MEMORANDUM

SUBJECT: DAP 2 Plant Production Increase Application
IMC-Agrico (New Wales)

Subject: IMC-Agrico Company (New Wales)
DAP 2 Plant Production Increase
File No. 1050059-020-AC, PSD-FL-241

Re: File No. 1050059-020-AC (PSD-FL-241)
New Wales Facility, DAP Plant No. 2

DAP II Venturi and Tail Gas Scrubbers

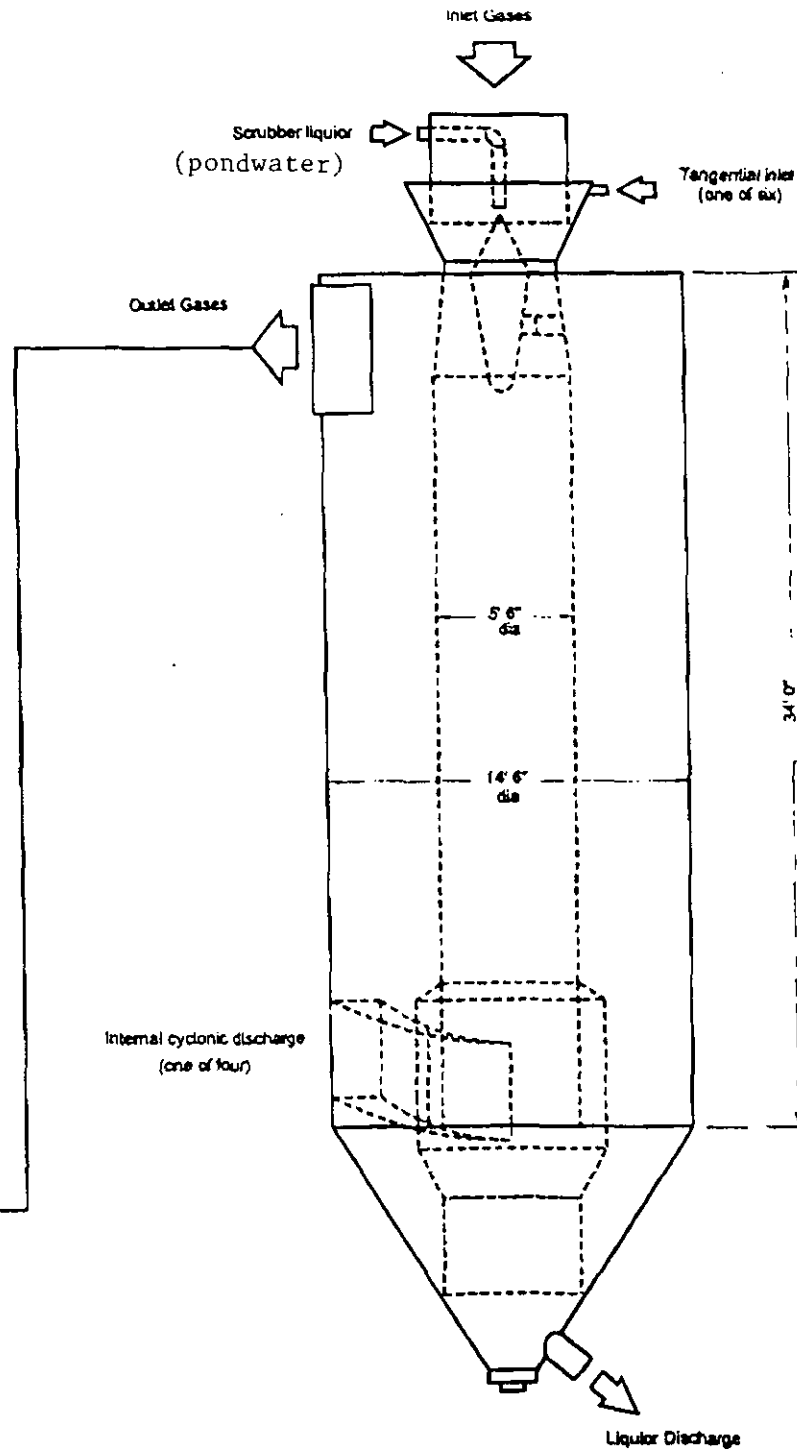
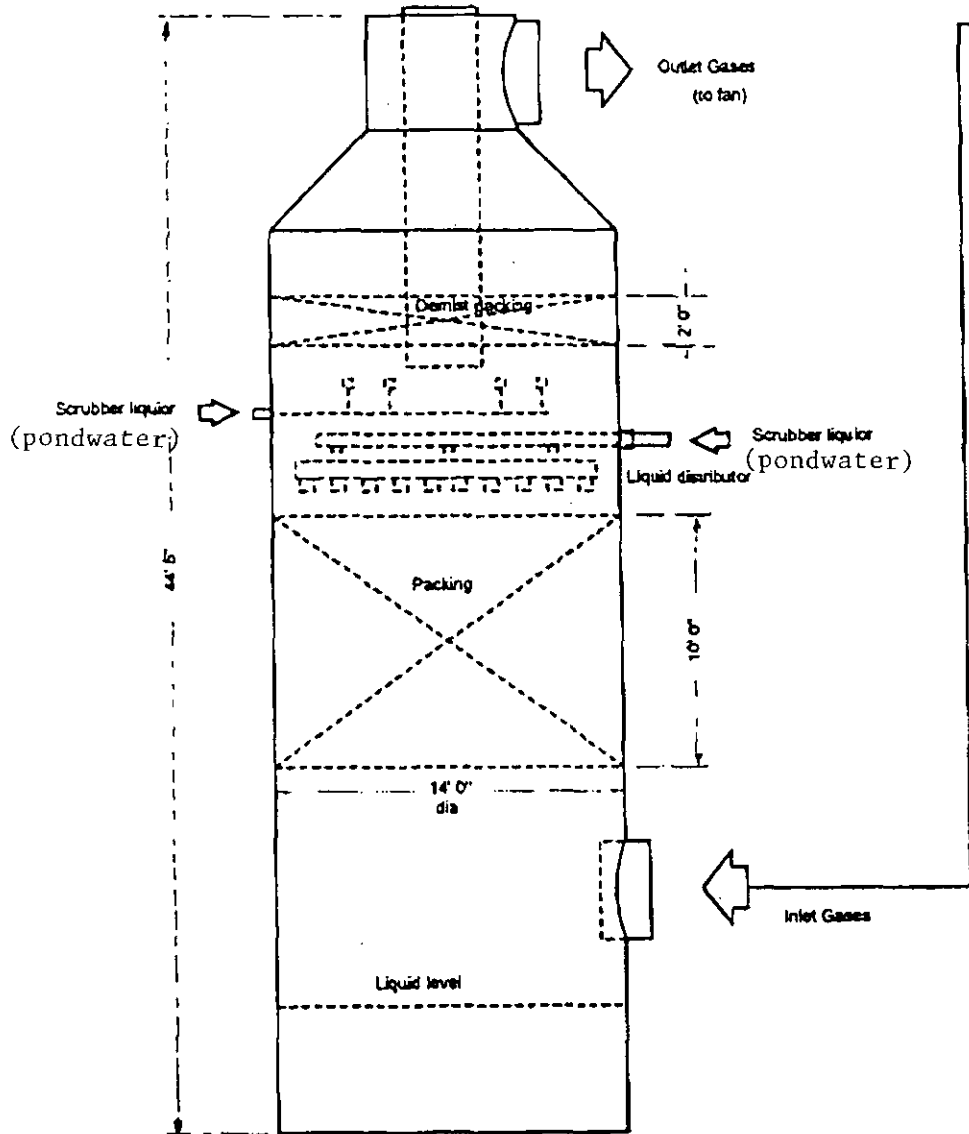
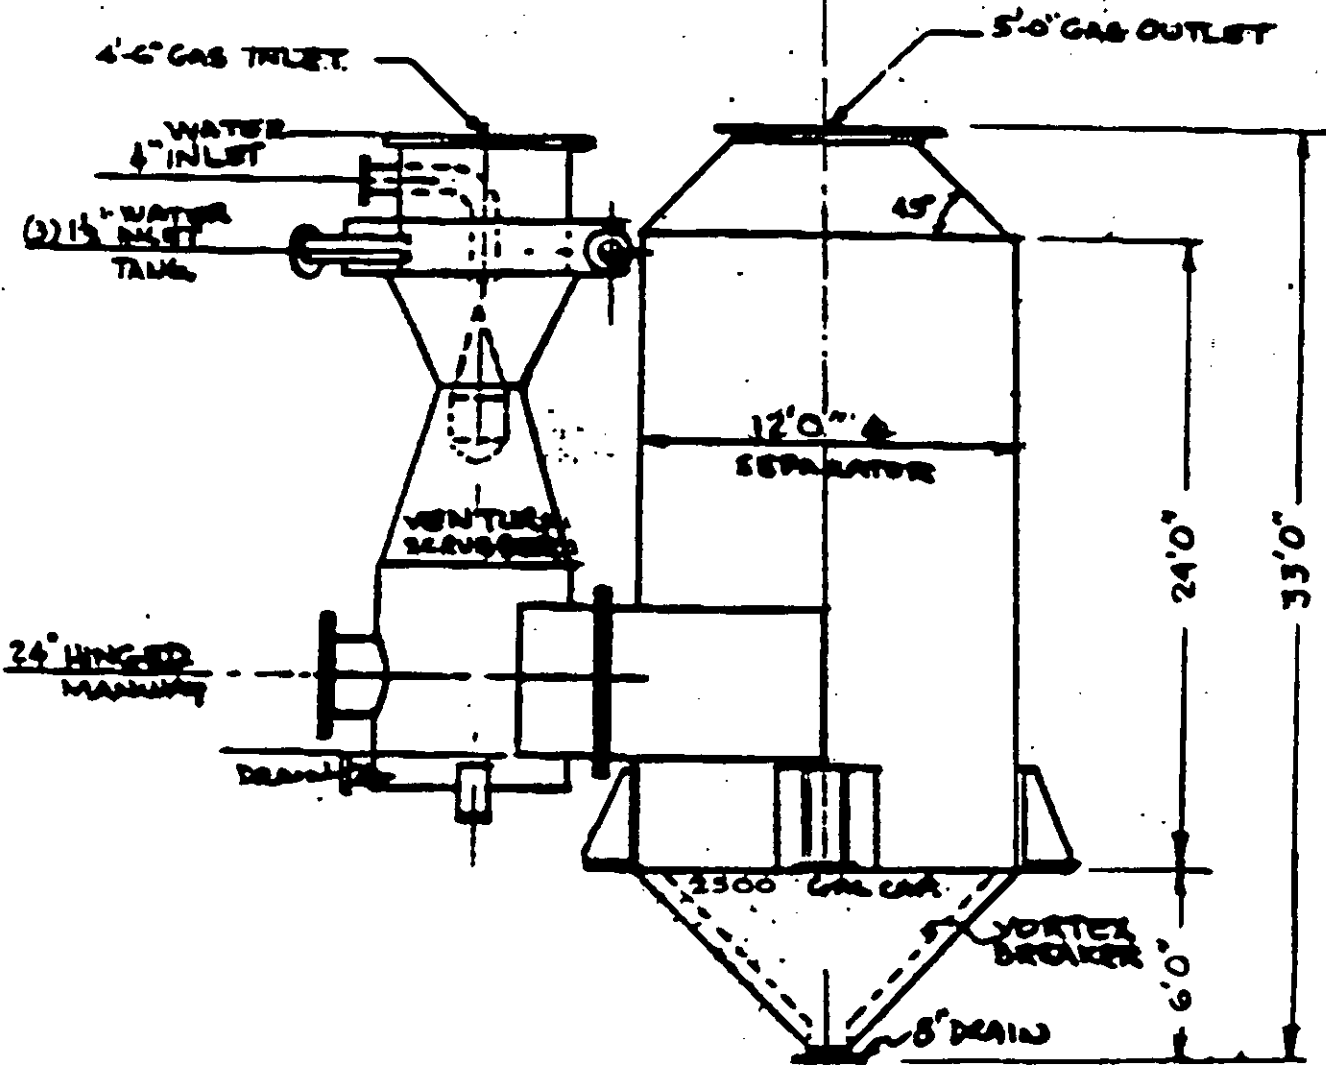
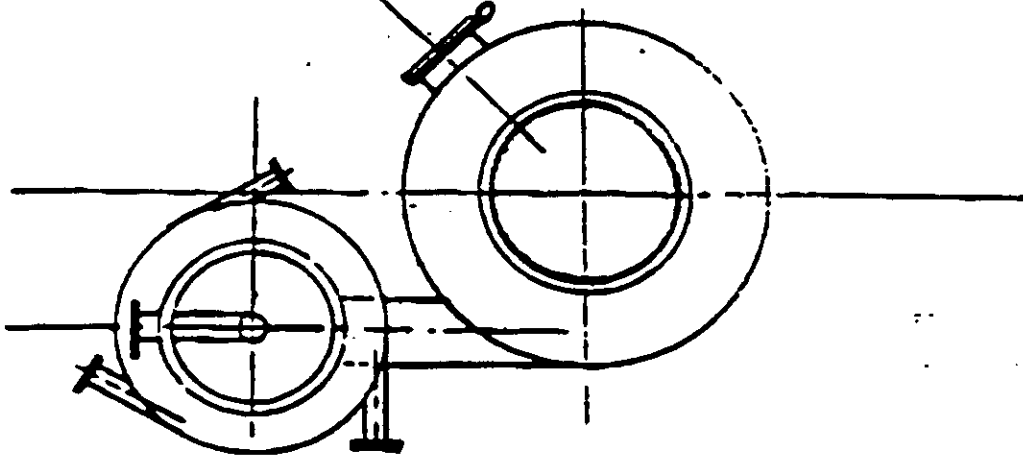
Drawings of the existing scrubbers, previously submitted to you, have been labeled per your suggestion and are presented in Attachments 2 and 3.
